RE: Lake Desire Management Plan SEPA checklist addendum

Technical Memorandum  
**Lake Desire Cost Benefit Analysis**

RE: Response to public comments on the Draft Lake Desire Management Plan

Re: Review of Draft Management Plan

Table 6-2

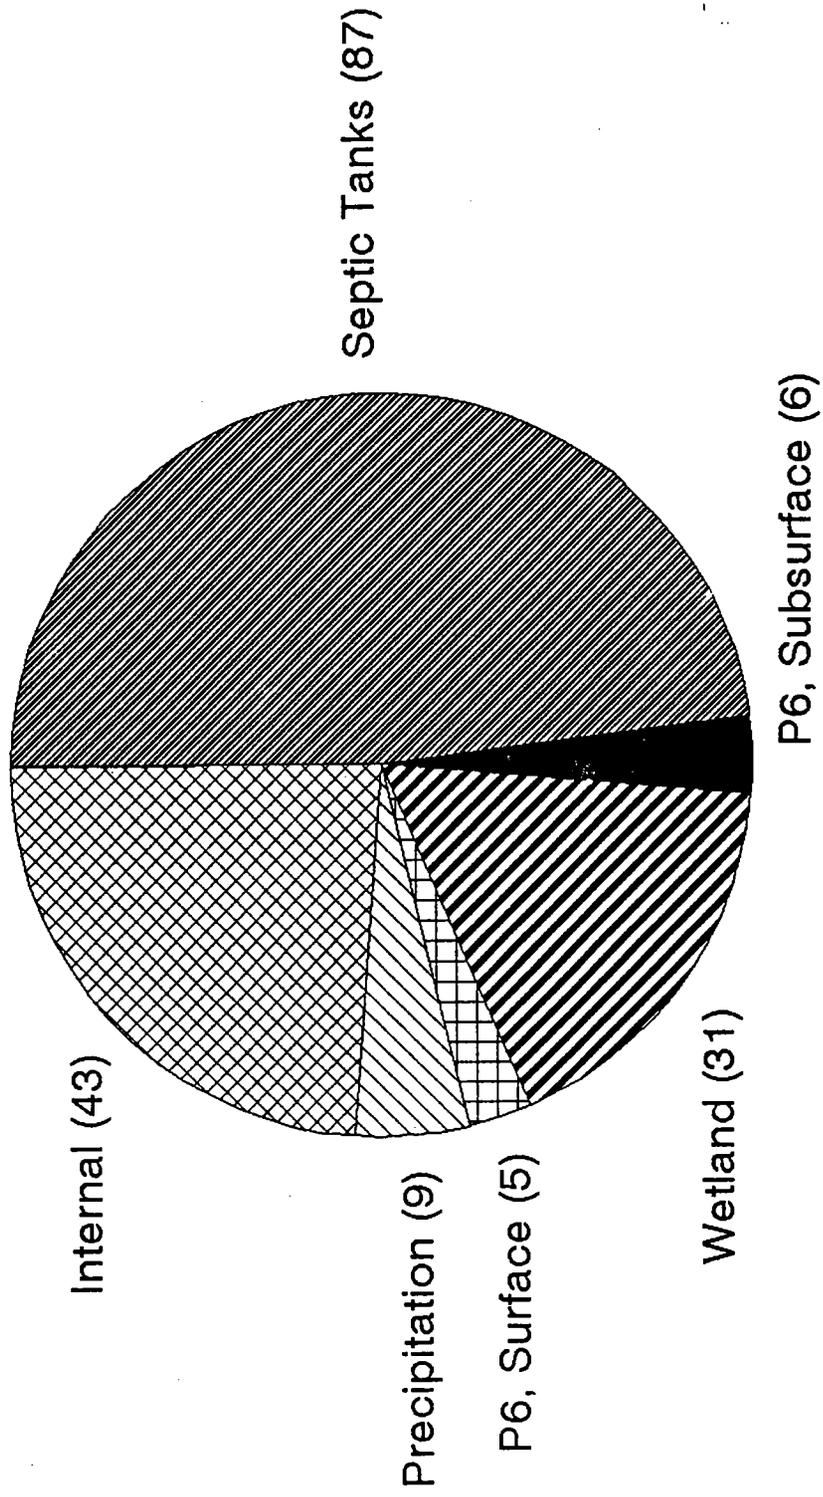
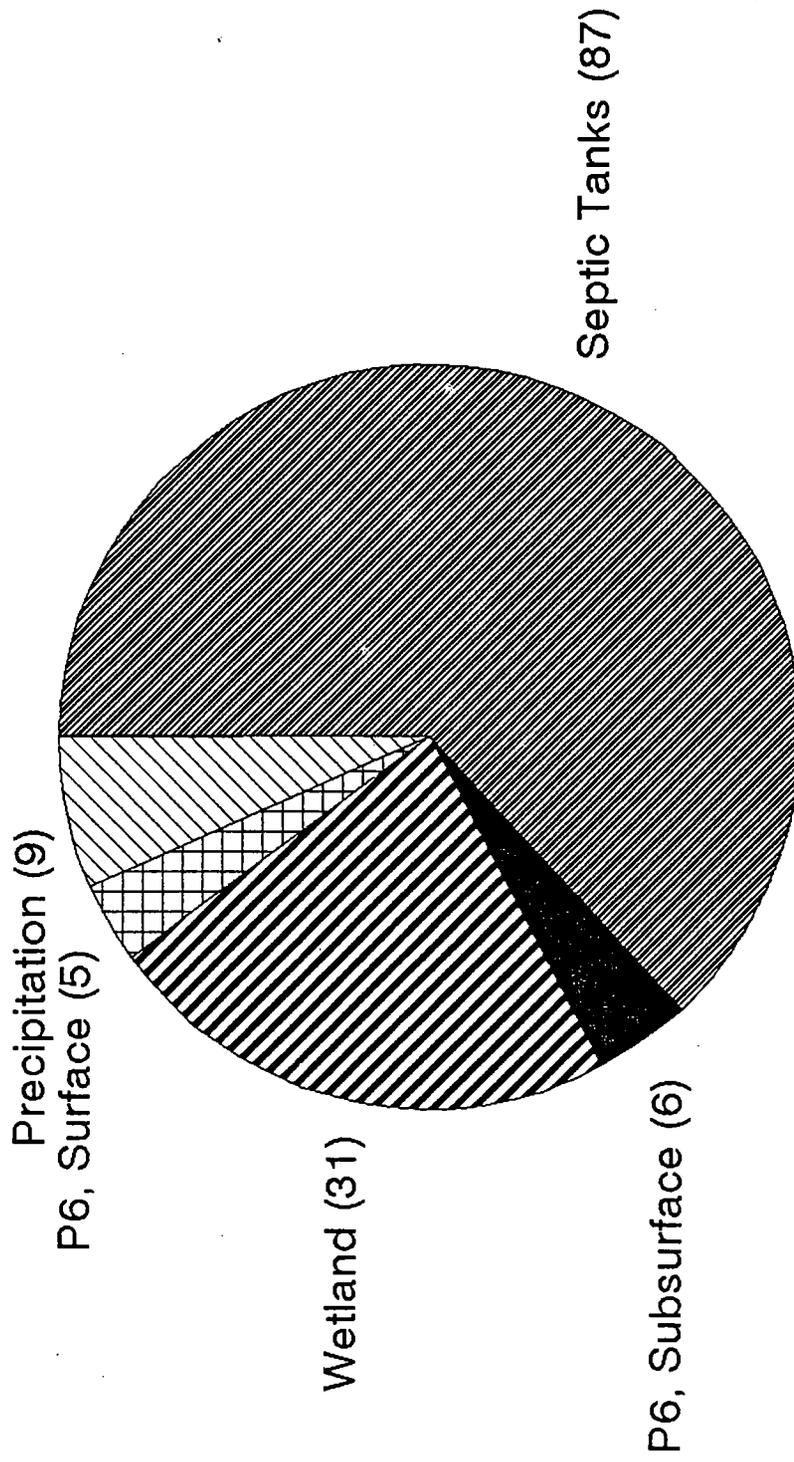
Lake Desire was found to be the third worst lake out of 16 lakes surveyed by Metro between 1972 and 1974. Only Cottage Lake and Lake Ballinger had poorer water quality. Although many factors enter into such a determination, phosphorus loading to the lake is a primary factor, contributing to low transparency and high algal biomass. (E.G. Welch, 1980, "The Ecological Effects of Wastewater") This generalization was specifically shown to be true in Lake Desire for most of the year, except November. (see Figure 4-6) The largest external contributor of phosphorus was found to be from subsurface flows into the lake. (Table 6-2)

**Septic systems are the greatest producer of this phosphorus.** The septic systems are contributing somewhere between 30 to 87 kg phosphorus (TP) annually to the lake. (page 6-6) The report is correct to provide both numbers showing the lower and upper end of an engineering estimate. The lower number assumes peak operating conditions, or 90 percent efficiency in removal. **Efficiency may not be this good because of the age of some of the septic systems and the poor soils in the drain fields. This is reflected in the higher number of 87kg phosphorus loading.**

5. For the management plan, on-site septic systems at Lake Desire were evaluated based on variety of sources including: 1) groundwater monitoring data; 2) review of the Seattle-King County Department of Public Health records; 3) the use of Aerial Shoreline Analysis and field surveys; and 4) the preliminary nutrient budget.

The 16 percent on site septic system "failure rate" discussed in the plan (pg. 4-38) correctly represents a "repair rate" recorded by the Seattle-King County Department of Public Health. For the final plan, the nomenclature will be corrected. The repair rate may include such activities as upgrading of the septic system based on the addition of rooms to a home or physical repair of the system due to failure. The rate does not provide any quantitative information regarding total phosphorus loading from on-site septic systems.
